## STAFF HEARING OFFICER STAFF REPORT

July 28, 2010

PROJECT ADDRESS: 903 W. Mission Street (MST2009-00388)

EXHIBIT A

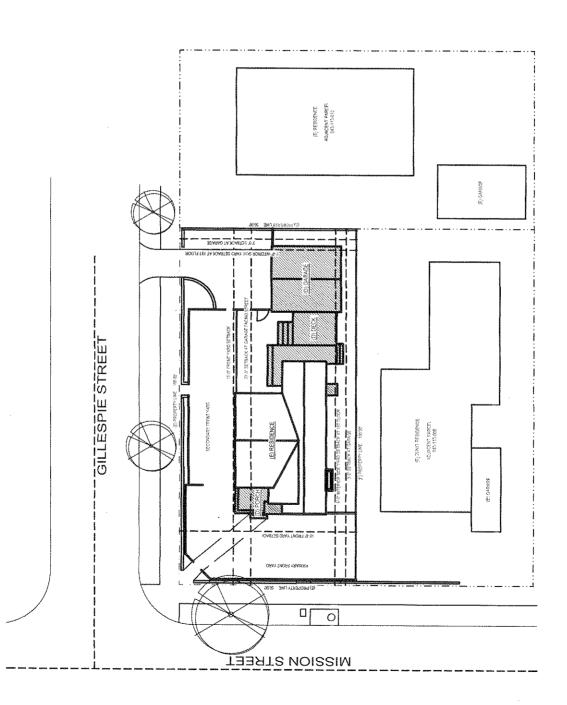
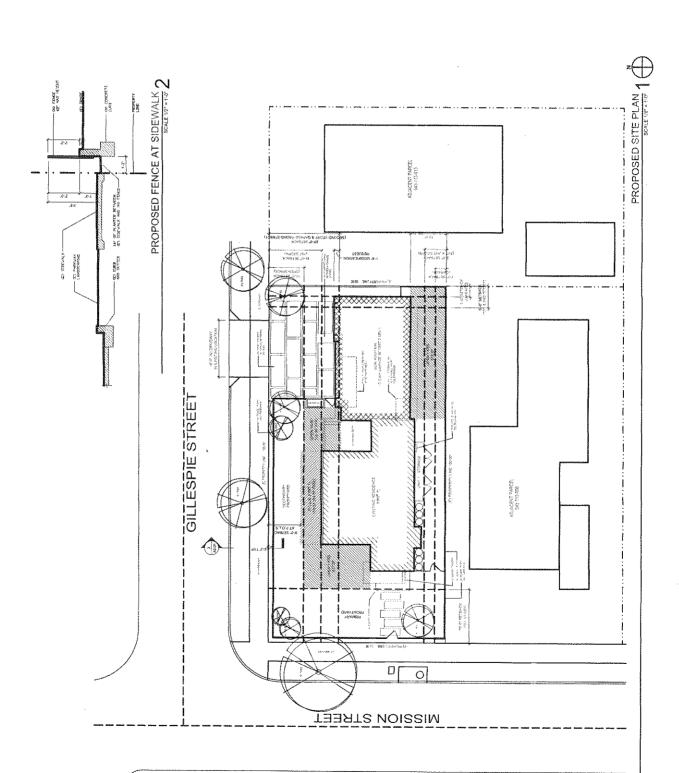
The subject property is located on the corner of West Mission and Gillespie Streets and therefore, has two front yard setbacks. The proposed project involves the construction of an accessory dwelling unit above a new 623 square foot three-car garage. Modification approvals are required for a new garage to be located within the required 20-foot front setback and to provide less than the required common open yard area of 600 square feet.

The existing 317 square foot garage is non-conforming to size and encroaches within the interior setback. The new garage is proposed to provide a third covered parking spot for the accessory dwelling unit, and would comply with the interior setbacks. However, in order to provide the required 10 foot width for the common open yard at the rear of the lot and the required 20' minimum interior depth of the garage, the applicant is requesting a modification for the garage to encroach approximately 18" into the 20' front setback on Gillespie Street. Staff's position is that requiring the garage to meet the 20' setback for garages facing the street would not benefit the project and would, in fact create the need for a modification of the common open yard minimum dimensions. Transportation Staff has reviewed the proposal, and prefers the requested encroachment into the front setback instead of reducing the interior depth of the garage by 18", because 12" of the encroachment is due to the thickness of the walls of the garage. The length of the area in front of the garage door is 19.5', which meets Transportation Division standards.

Two dwelling units are allowed on this 5,000 square foot lot in the R-2 Zone, with the special provisions for accessory dwelling units. Common open yard on lots developed with accessory dwelling units requires that the open yard may be provided in one area of at least 600 square feet or two areas, each of which must be at least 300 square feet, each with a minimum dimension of 10'x10'. The existing house is situated on the lot in such a way that that neither of these open space requirements can be met and additionally, the lot is constrained with two front setbacks. However, the project does meet the locational requirements for the open yard and provides one area of 375 square feet for the new unit residence, two areas of 237 and 130 square feet, each meeting the 10'x10' minimum dimension, for the existing residence. Additionally, the project meets the requirements for the private outdoor living space for both units as well as provides areas for enjoyment of the yard. Although the minimum area of 300 feet is not being met for the front unit, it is Staff's position that adequate open yard is being provided.

The Staff Hearing Officer finds that the front setback modification is consistent with the purposes and intent of the Zoning Ordinance and is necessary to secure appropriate improvement on the lot. By allowing the proposed three-car garage to encroach 18" into the front setback, the project meets current Municipal Code requirements by providing three parking spaces on site, while still providing a useable space at the rear of the lot.

The Staff Hearing Officer finds that the Modification of the open yard for the front unit to be less than the required 300 square feet is consistent with the purposes and intent of the Zoning Ordinance and is necessary to secure an appropriate improvement on the lot. Although one area does not meet the minimum dimension of least 300 square feet, the project provides enough area by providing three separate open yard areas totaling more than the required total of 600 square feet.
